DEPARTMENT OF NATURAL RESOURCES  
DIVISION OF OIL, GAS AND MINING

ATTACHMENT II-I

RE: Proposed Texaco Access Road, PacifiCorp, Cottonwood Waste Rock Site, ACT/015/019-96C, Folder #2, Emery County, Utah

DIVERSION DITCH

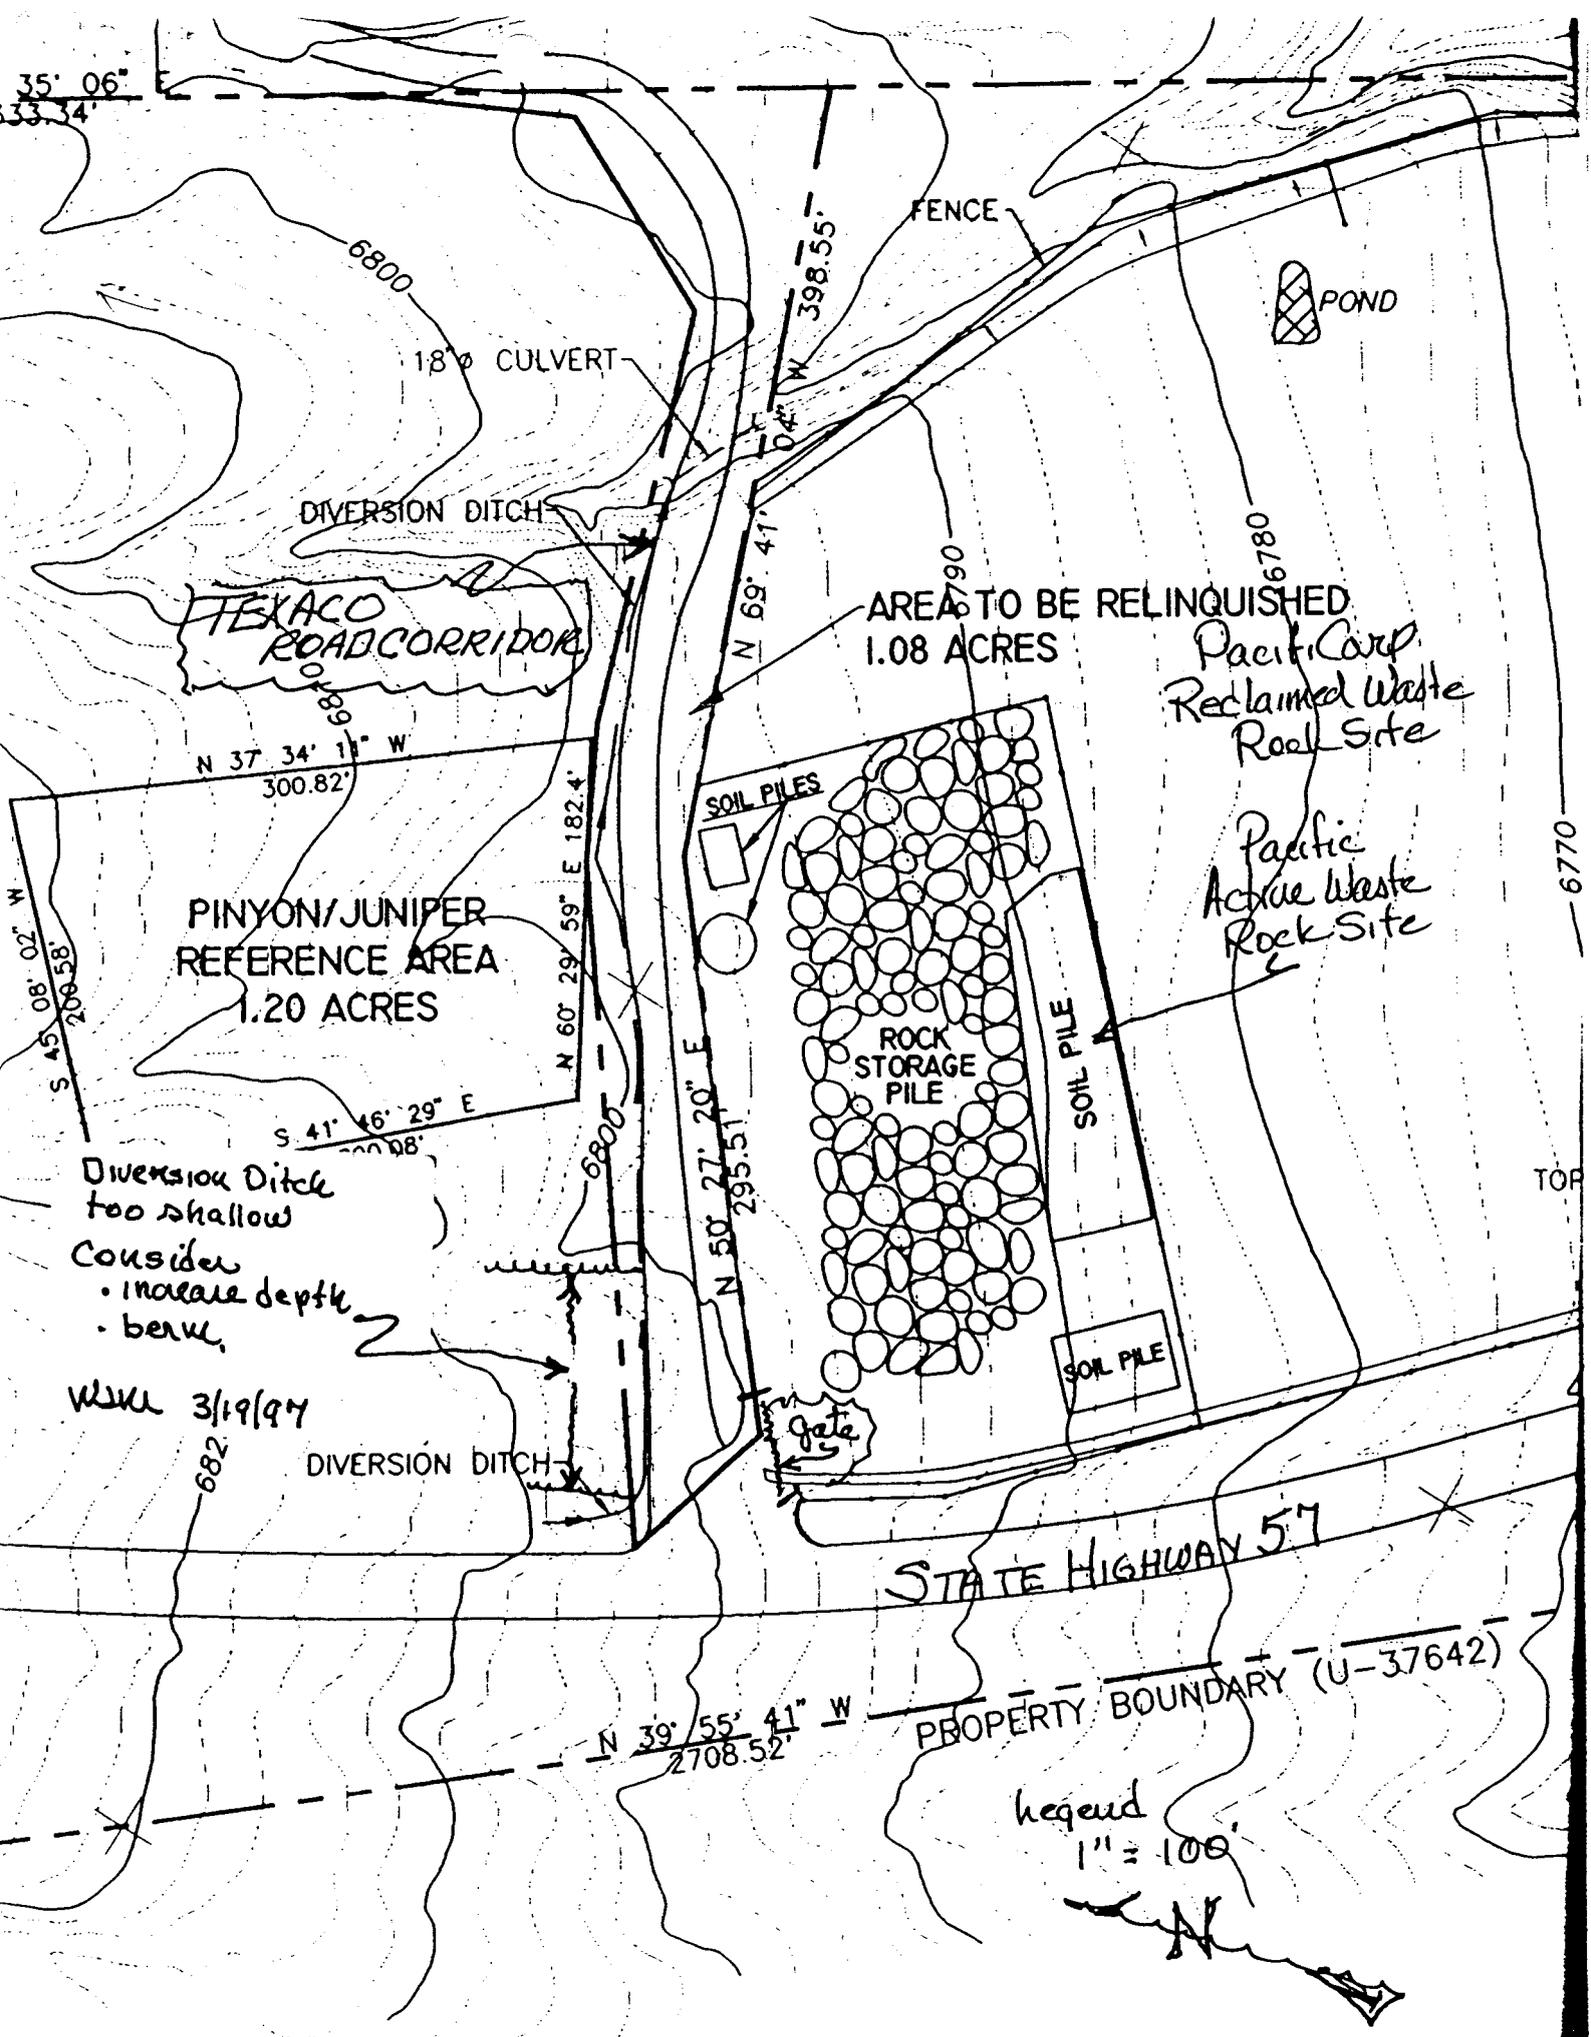
Based on understandings reached at a field meeting as covered in my minutes of July 25, 1996, your concurrence letter of September 9, 1996, your company is responsible for the ditch shown on the attached sketch. I conducted an inspection on March 14, 1997, and noted that the northwesterly segment of the ditch is very shallow and has a potential to over top and drain into and commingle with the waste rock disturbed runoff. Should this occur, it would result in a violation to PacifiCorp issued by the Division of Oil, Gas, and Mining.

When the Texaco road was constructed, the ditch was not altered. Later when the pipeline was buried, the ditch was altered.

Diversion Ditch too shallow  
Consider  
• increase depth  
• berm

I have received excellent cooperation from both PacifiCorp and Texaco primarily pointed toward meeting your needs. It was agreed we would utilize existing disturbed areas for the road construction, to the extent feasible, and not disturb any wildland areas. I would appreciate your doing the necessary maintenance/ reconstruction ditch work to prevent any possible compliance problems. This particular ditch has been designed for 100 year 6 hour storm event. PacifiCorp can provide you the design and any other information that concerns this ditch.
